**PRODUCT CHANGE NOTICE**  
PCN Form (D4-E000-73)

**PCN #09-002**

LZY-1X+ & LZY-1+  
Case Style: BT1312

Attachment to [PCN#09-002](#)

**BT1312**

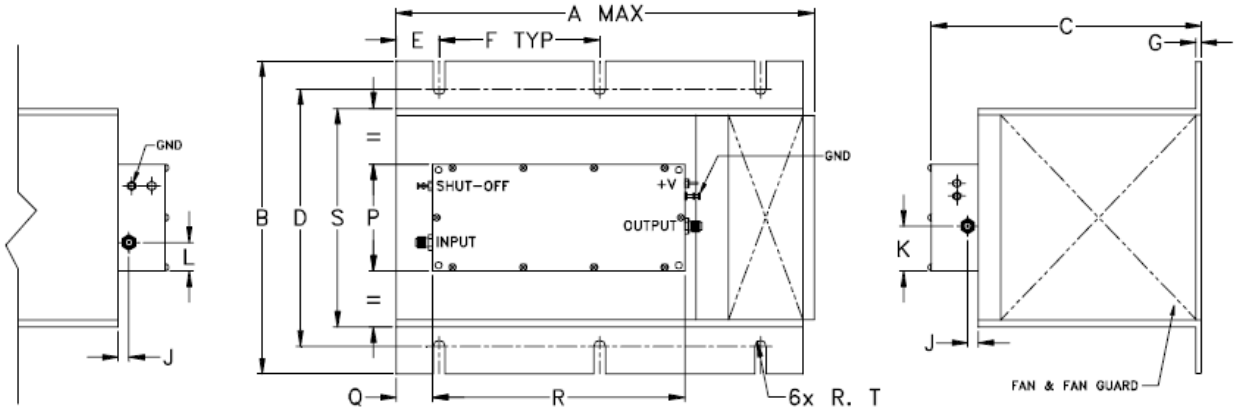
Mechanical dimension of amplifier enclosure

LZY-1X+ Non-Heat Sink Version	Mounting Hole Length from 5.025" to 5.605"
LZY-1+ Heat Sink Version	Dimension R from 5.30" to 5.88"

Enclosure redesign for manufacturability.
